Lot 14 Banfield

Proposed
master/main
bath
reconfiguration

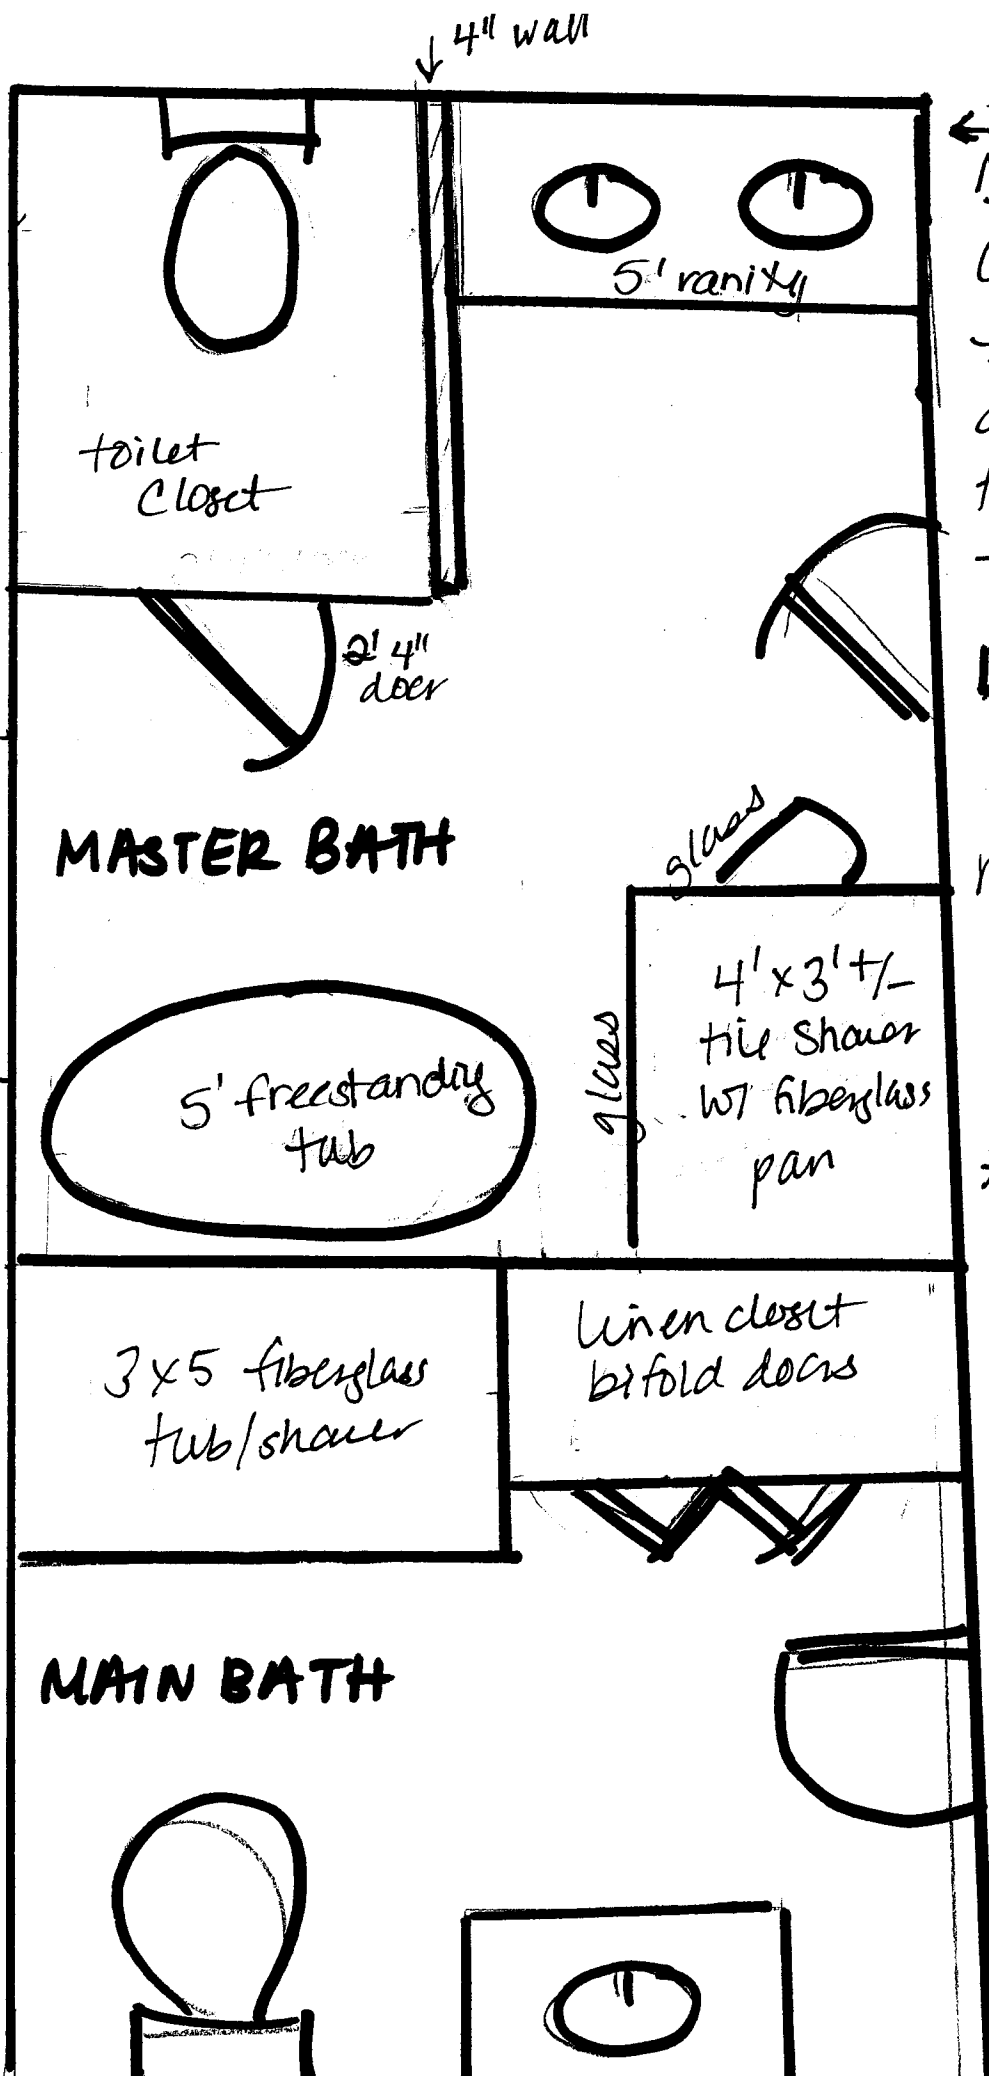
master bath increased by 3' +/-
space removed from main bath

Note - vanity
cannot be larger
than 62" in
order to fit
toilet closet
